NOTICE OF DECISION

PLANNING ADMINISTRATOR DECISION FOR SITE PLAN REVIEW

CASE TYPE: Class 2 Site Plan Review
AMANDA NO.: 21-114799-RP
DATE OF DECISION: March 1, 2022
PROPERTY LOCATION: 3995 Rickey St SE
APPLICANT: Magellan Architects (on behalf of McDonald's Corporation)
REPRESENTATIVE: Jamie Trendera
ZONE: CR (Commercial Retail)
COMPREHENSIVE PLAN: COM (Commercial)
OVERLAY: None

Attachment A

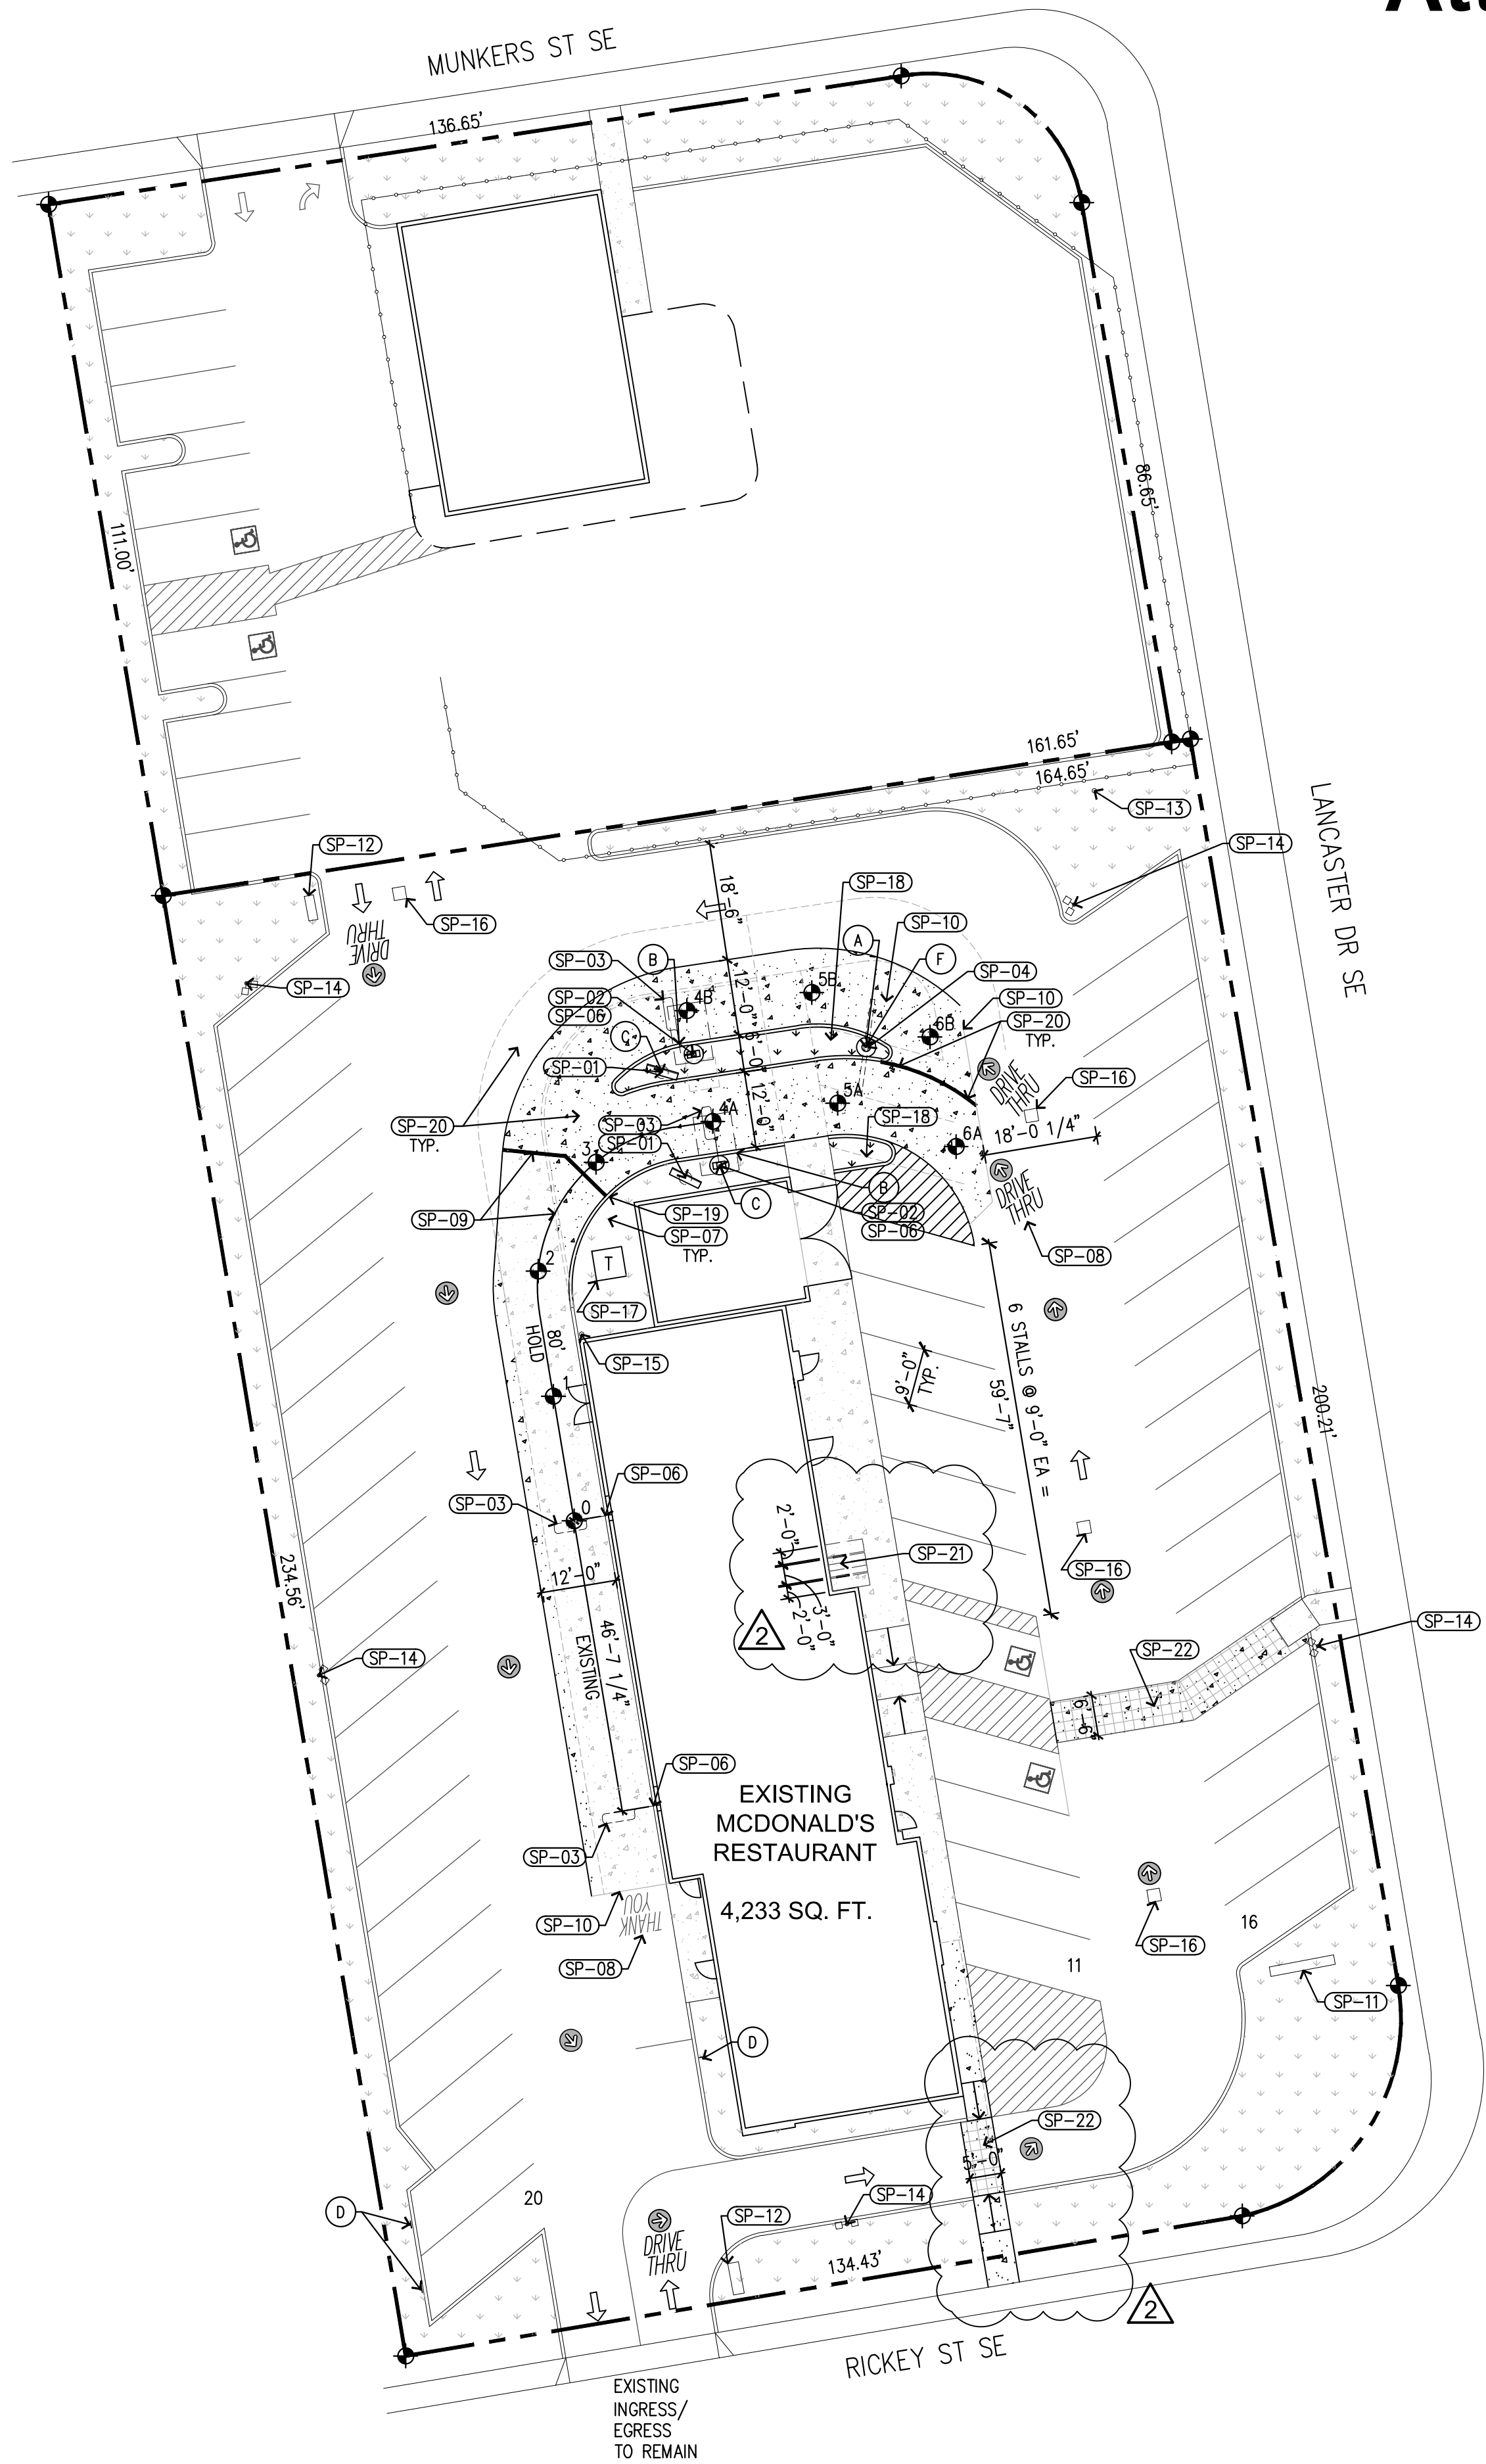
Finding: As identified above, the setbacks and vehicle uses areas are either conforming or considered nonconforming in regard to setbacks and landscaping. The site is approximately 38,332 square feet requiring a minimum of 15 percent of landscaping, or 5,750 square feet of landscaping; per the site plan 5,961 square feet is proposed meeting the standard.

Finding: As shown on the proposed site plan, the existing pedestrian walkway is shown to connect from the primary building entrance to Lancaster Drive SE. Additionally, a new connection is proposed from the primary building to Rickey Street SE. There is no transit stop, existing or planned, along the either street frontage of the development site (i.e. Lancaster Drive SE or Rickey Street SE). The proposal meets the standard.

Finding: Proposed walkways are indicated on the site plan as being paved with a concrete surface and are proposed to be a minimum of five-feet in width. Full adherence to the pedestrian access requirements set forth in SRC Chapter 800 will be reviewed at the time of building permit application.

Finding: The parking area is existing with changes proposed to the interior landscaping. The northern portions of the off-street parking and vehicle use area, where the improvements are proposed, measures to approximately to 9,546 square feet; 5-percent of that area is 477 square feet (i.e. $9,764 \times .005 = 488.2$). As displayed in the proposed site plan (**Attachment A**) the interior landscaping standard is met with approximately 2, 037 square feet of interior landscaping. The proposal meets the standard.

Finding: The existing 4,233 square foot *eating and drinking* establishment requires a minimum of four bicycle parking spaces. As shown on the site plan, four bicycle parking spaces are shown abutting the main, western entrance. The bicycle parking spaces are on the same development site. These standards are met.

Finding: The proposed bicycle parking spaces are proposed approximately 36-45 feet from the primary entrance; the proposal meets this standard.

Finding: As shown on the proposed site plan, the proposed bicycle parking areas have direct access to the public right-of-way through the existing pedestrian paths to Lancaster Drive SE that go through the existing the vehicle use area. Additionally, the bicycle parking areas have direct access to primary building entrances through the proposed pedestrian pathways in conformance with the requirements of SRC 806.060(b). The bicycle parking utilizes the ADA-ramps proposed on site removing any barriers that would require lifting of bikes. The proposal meets the standard.

Finding: The proposed bicycle parking spaces meet the minimum dimensions for bicycle parking spaces and are adjacent to the proposed pedestrian walkway. The spaces are adjacent to pedestrian accessways, providing a minimum 4-foot-wide access aisle. The proposal meets the standard.

Finding: The applicant has proposed racks which appear to meet these standards. Full adherence with these standards will be ensured at the time of building permit review.
